# ***Acheron***

RE: Response to Comments Final Major Subdivision Application Durant Homestead, Residential Subdivision.

The purpose of this submittal is to address Town of Windham's review comments regarding the Durant Homestead, Final Major Subdivision Application. Comments were provided in an email from Gorrill Palmer, dated February 14, 2019. Below you will find comments provided by the Windham in italic font followed by a response by Matt Hancock Properties LLC in regular font.

Drawing No:  
C-2

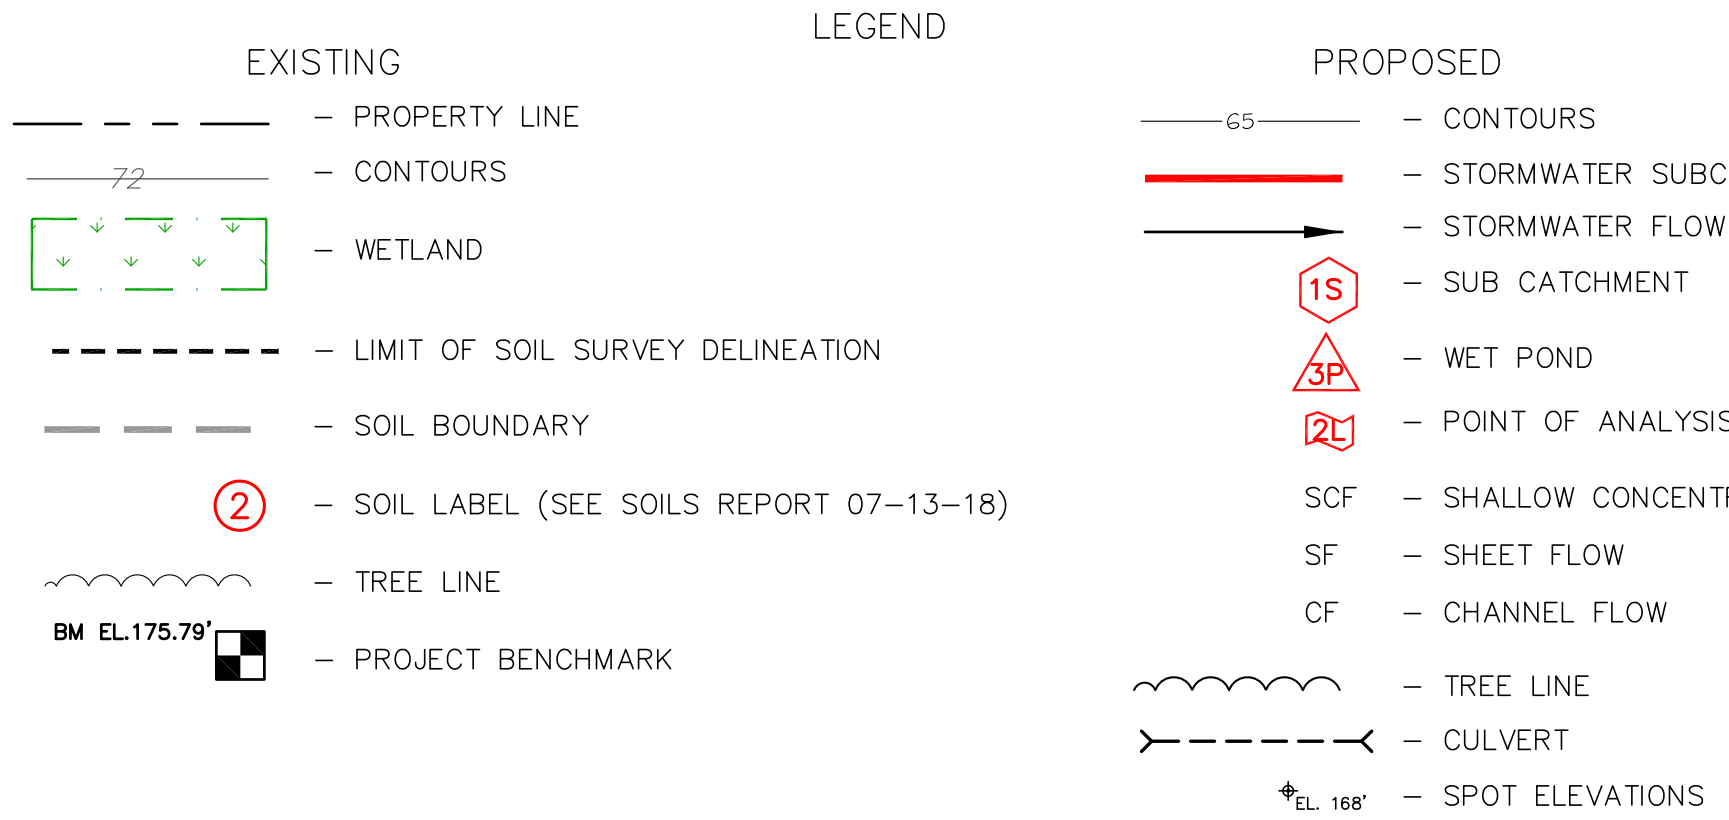
- 1. Final Subdivision Plan (no sheet #) – Open space areas should be labeled similar to the lot areas.*

- 2. Final Subdivision Plan (no sheet #) – As noted by Jon Earle in previous review, percentage of developable land in open space (Note 12) appears to be incorrect. The denominator does not match the total open space area provided in Note 11.*

- 3. Final Subdivision Plan (no sheet #) – Plan shall be stamped by a Maine Licensed Professional Engineer and Professional Land Surveyor.*

- 4. Final Subdivision Plan (no sheet #) – Granite Monuments shall be installed in accordance with Section 911.A.3(a).*

5. *Final Subdivision Plan (no sheet #) – Some proposed well locations are within 100’/150’ of the proposed travel way. As stated in Section 911.B.1(c)(I)(iii), wells shall not be constructed within 100’ downgradient of travelways or 50’ uphill from travelways.*

6. *Final Subdivision Plan (no sheet #) – We recommend that the plan show all lot setbacks (front, side, rear).*

7. *Final Subdivision Plan (no sheet #) – We recommend that the plan include all space and bulk criteria for a cluster subdivision in a farm zone.*

8. *Final Subdivision Plan (no sheet #) – It should be noted that the proposed tree line does not appear to include the proposed lot development.*

The Final Subdivision Plan, attached has been revised to include labels for the open space areas that are similar to the lot labels.

The area of land proposed in open space equals 40.37 acres as indicated in Note 11. This figure includes areas that are not developable (wetlands and slopes over 25%). The developable area designated as open space equals 27.20 acres. This figure is the area designated as open space minus wetlands and slopes over 25% (40.37 acres - 13.17 acres). Note 12, calculates the percentage of reserved open space within the full parcel. As mentioned above the developable area in open space is 27.20 and the developable area within the full parcel is 48.53 acres (same as net residential area),  $(27.20/48.53) = 56\%$ . Note 12 has been revised to clarify.

The attached Final Subdivision Plan include the design engineer's stamp and signature.

The Final Subdivision Plan has been revised per Section 911.A.3(a).

Section 911.B.1.(c)(I)(iii) requires water supply wells to be constructed 100 feet from a traveled way if located downhill from the street, or within 50 feet of a traveled way if located uphill of the street. Review of the site plan only 8 wells were identified that did not meet this requirement. As discussed with the Windham Planning and Code Enforcement the intent of this requirement makes sense for dug wells which happens to be the primary topic of this section. It is presumed that the purpose is to limit the public’s exposure to any contaminate from a travel way reaching a dug well. Based on discussions with the town staff Matt Hancock Properties is requesting the Planning Board to waive this requirement for the following reasons:

The Final Subdivision Plan has been revised to show structures setbacks.

The space and bulk criteria for a cluster subdivision is included on the attached version of the Final Subdivision Plan.

During the preliminary subdivision planning board review process, the Board approved a not showing the proposed tree line for the lots that are not regraded to meet stormwater standards. The basis for this approval is the Durant Homestead Stormwater Treatment

Drawing No:  
C-6

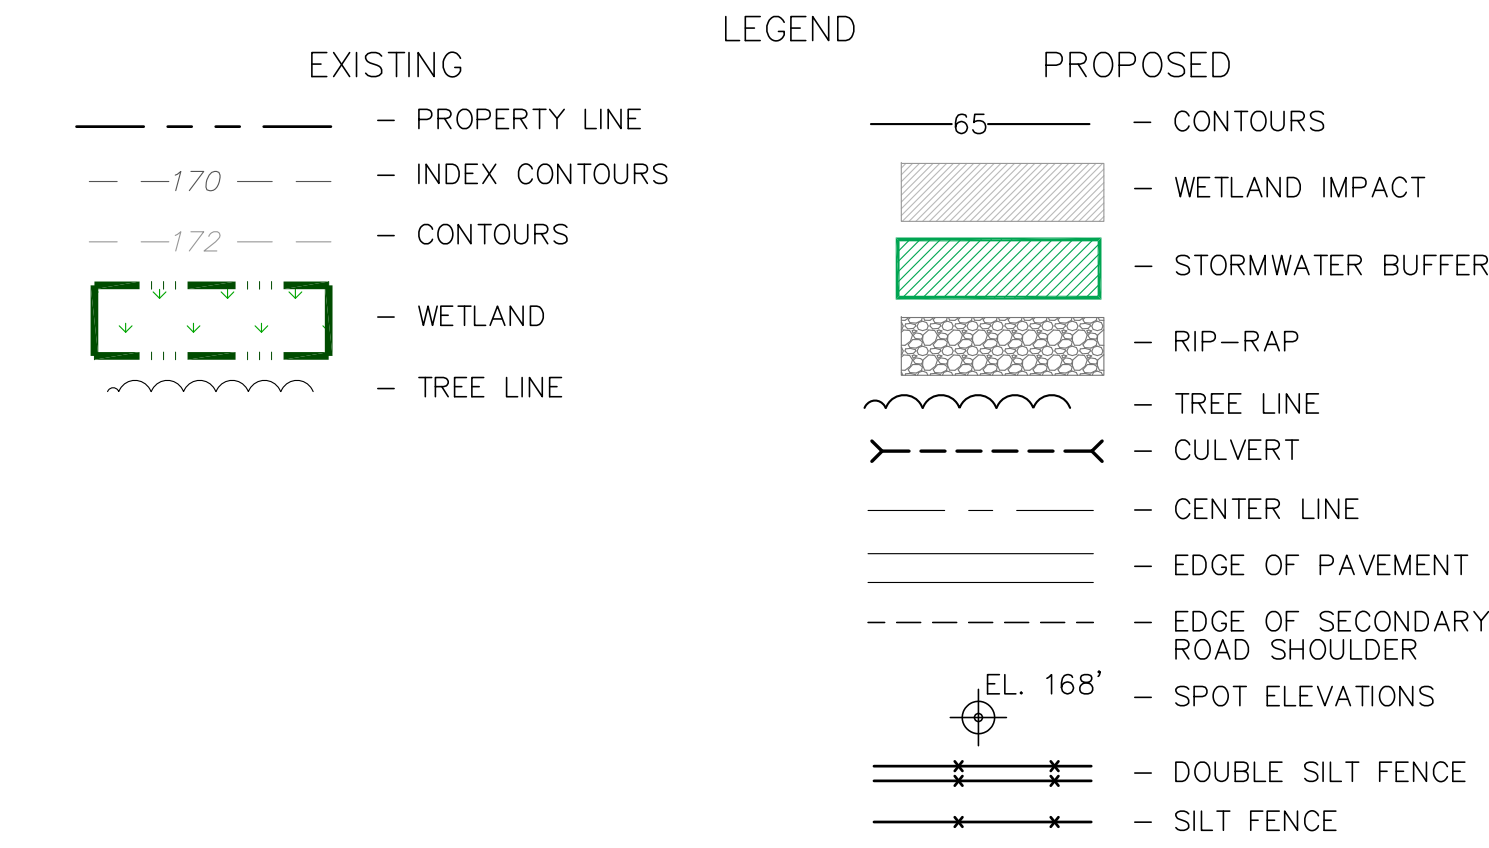
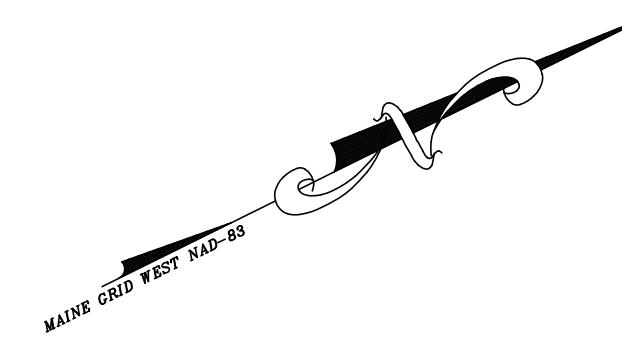
10. *Site Plan (C-6) – Construction entrance does not appear to be shown in the correct location.*

11. *Site Plan (C-6) – Building envelopes/setbacks should be revised to exclude any wetlands within the lots.*

The construction location has been relocated on sheet C-6.

Building envelopes/setbacks have been revised on C-6 to exclude wetlands.

SPEED LIMIT SIGN POST DETAIL  
NOT TO SCALE

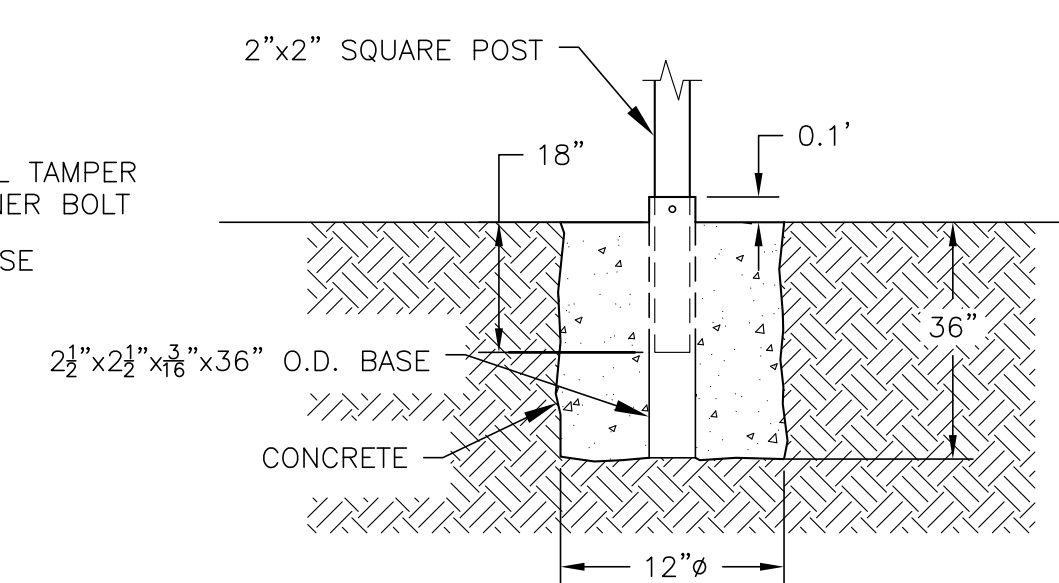
15. *Profile Plan (C-10) – Sag curve at Sta. 5+50 does not meet the required minimum K value in the AASHTO green book (26 minimum for 25 mph design speed). Given that this road may be submitted for acceptance as a Town Public Road, we would recommend that this vertical curb be revised to meet AASHTO requirements.*

Matt Hancock Properties understands the reasoning for this recommendation and want to point out that is a recommendation and not a requirement. The sag curve as designed has been evaluated using AASHTO green book. The sag curve shown has a "K" value of 13 which falls between 15 and 20 MPH. Matt Hancock Properties proposes to post a speed limit of 15 MPH for Penny Whistle Lane, which is a more appropriate speed limit for a clustered subdivision. Sheets C-9 and C-11 have been revised to include speed limit signs and installation detail.
